Appl. No. 10/537,544  
Amdt. dated August 24, 2007  
Reply to Office action of May 25, 2007

**AMENDMENTS TO THE DRAWINGS**

Annotated Sheet Showing Changes

Fig. 2

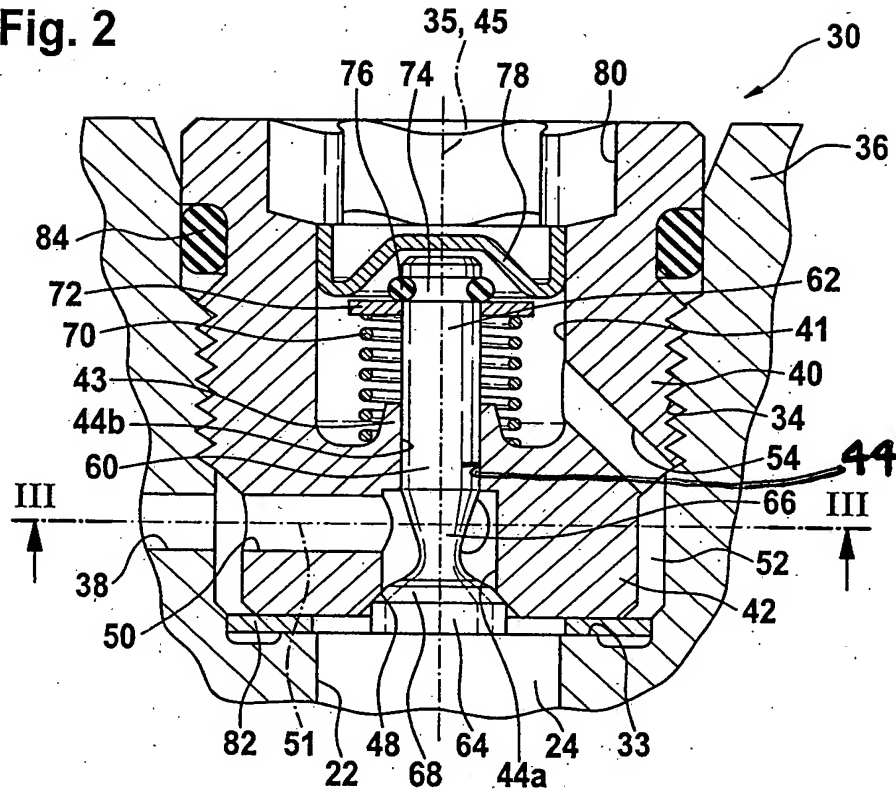
The attached replacement sheet of drawings includes changes to Figs. 2 and 3. The replacement sheet, which includes Figs. 2 and 3, replaces the original sheet including Figs. 2 and 3. In Fig. 2, reference numeral "44" and in Fig. 3, section line IV-IV have been added.

The drawings have been objected to because reference numeral "44" is missing. Fig. 2 has been amended to include Fig. 2. Also, the section line IV-IV, referred to in paragraph [0008] of the specification, has been added. Accordingly, withdrawal of the objection is requested.
